Re: On-Going Services  
Drainage Review of 25 Windermere – **New Pool, First Revision, First Submittal**  
Piney Point Village, Texas  
HDR Job No. 10361768

We are in receipt of the proposed drainage plan for the above referenced address, with engineer seal dated 2/13/2023. Please make the following changes to the drainage plan:

DRAWING TITLE:  
DRAINAGE  
PLAN

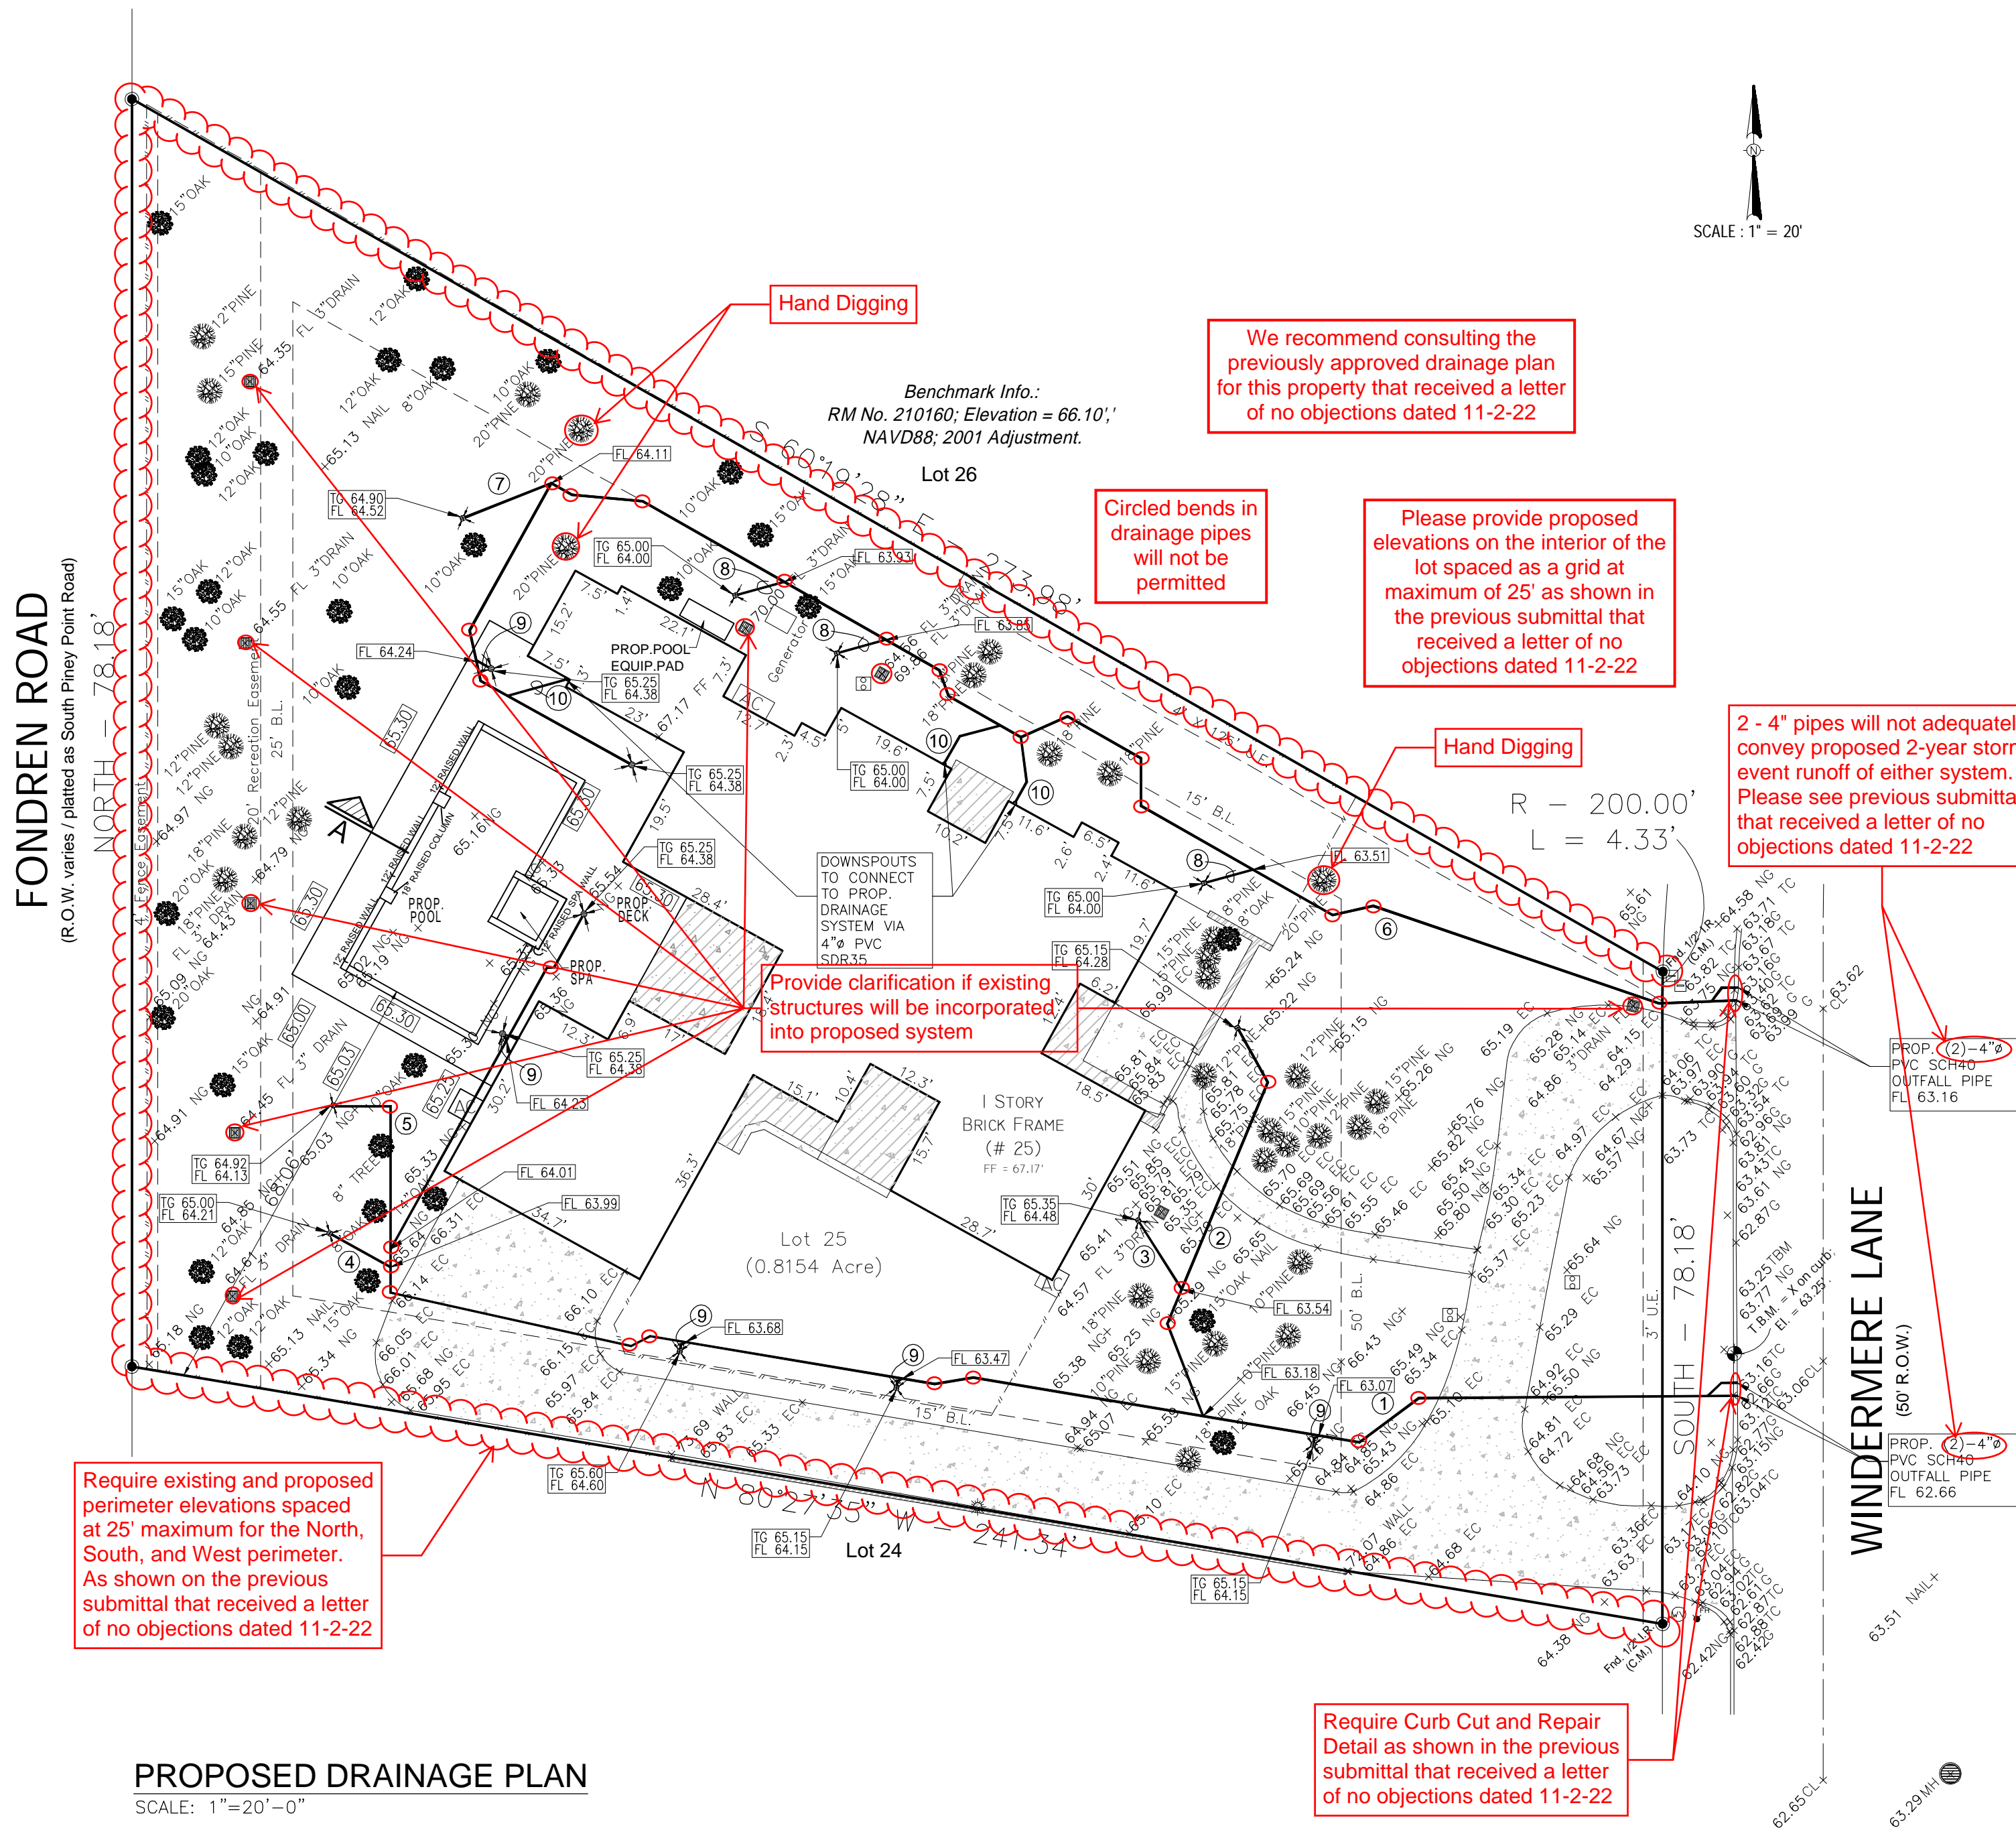
1. Per City drainage criteria, the Drainage Plan shall show existing and finished grade elevations of all proposed paving and grading on the site and shall include existing and planned spot elevations at a maximum of twenty-five foot (25') spacing covering the lot, including shots on 25' spacing along the perimeter of the lot, grid across the lot, and along the perimeter of all structures (i.e., building slabs, sidewalks, patios, driveways, decks, etc.). It appears that existing and proposed elevations at a maximum of twenty-five foot (25') spacing covering the lot, including shots on 25' spacing along the perimeter of the lot, grid across the lot, and along the perimeter of all structures were not provided on the drainage plan as shown in the previous submittal that received a letter of no objections dated 11/2/2022. Please revise the drainage plan to ensure this criterion is met.

2. Per City drainage criteria, the drainage system must include a clean-out, inlet, or junction box at every bend so as to provide access for maintenance; the only exception may be where roof drains tie into the main system. It appears there are several locations of proposed bends in the pipe that do not have a clean-out, inlet, or junction box at the bend. Please revise the drainage plan to ensure this criterion is met.

3. Per City drainage criteria, all proposed drainage pipes shall be sloped to achieve a velocity of at least 3ft/sec. It appears that there are two proposed pipes that are not adequately sloped to achieve a velocity of at least 3ft/sec. Please revise the drainage plan to ensure that all proposed pipes are sloped for a velocity of at least 3 ft/sec to ensure this criterion is met.

4. Per City drainage criteria, when the design calls for a system to discharge through an existing concrete curb, the plan submitted must include a curb cut and repair detail. It appears that the curb cut and repair detail that was included on the previous submittal that received a letter of no objections dated 11/2/2022 was removed from the drainage plan. Please revise drainage plan to show a curb cut and repair detail to ensure this criterion is met.

5. Per City drainage criteria, the engineer shall provide drainage area calculations using Atlas 14 rainfall data for a Harris County Region 2 2-Year storm event on the submitted plans. It appears that the drainage plan shows that the two proposed 6-inch outfall pipes on the east side of the lot will be reduced to two 4-inch pipes before outfalling through the curb along the street. It also appears that these 4-inch pipes will not have the required capacity to convey the flow produced on the lot during a Harris County Region 2 2-Year storm event at their proposed slope. Please revise the drainage plan to ensure that all proposed drainage pipes are adequately sized to convey the flow produced on the lot. Also, please verify the "Flow Capacity" column provided in the Proposed Storm Drain Pipe Schedule table on the drainage plan as it appears that some of the capacities provided do not correspond to the proposed pipe sizes and slopes shown in the table.

6. Per City drainage criteria, any excavation in the vicinity of trees 20 inches in diameter and above shall be completed by hand digging. Locations of hand digging around trees must be called out on the drainage plan. Please revise the drainage plan to call out locations of hand digging around trees where required to ensure this criterion is met.

7. Per City drainage criteria, the drainage plan shall include all aspects of the anticipated development including but not limited to building foundation, patios, decks, swimming pools, drives, walks, landscaped areas, downspouts, **drainage system**, etc. It appears that the permanent drainage plan shows existing drainage structures on the property that are not proposed to be removed or tied into the proposed drainage system. Please provide clarification for what parts of the existing drainage system will be incorporated into the proposed system and what parts will be removed as part of the scope of work and revise the drainage plan accordingly.

SWPPP PLAN

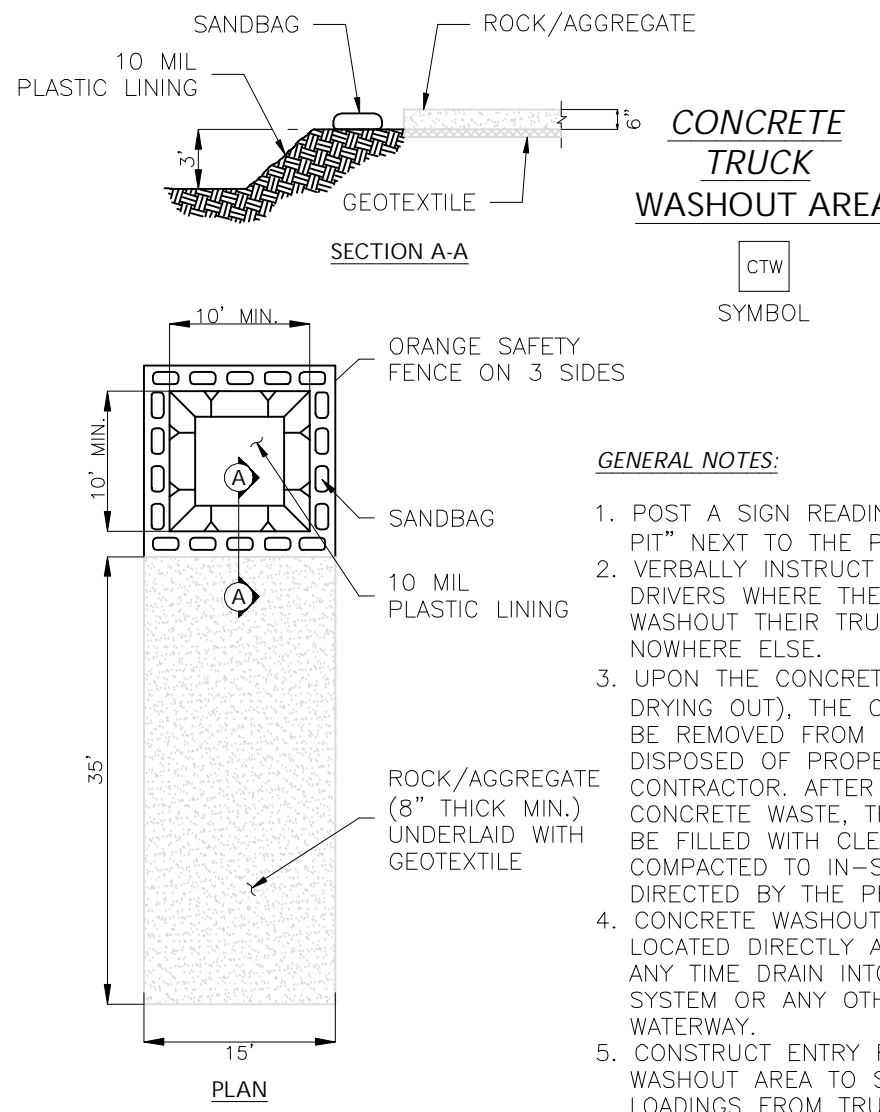
8. It appears that the sign and seal date on the Temporary drainage plan was not updated and is dated prior to the previous submittal that received a letter of no objections dated 11/2/2022. Please ensure that the Temporary Drainage plan includes a revised date upon resubmittal.
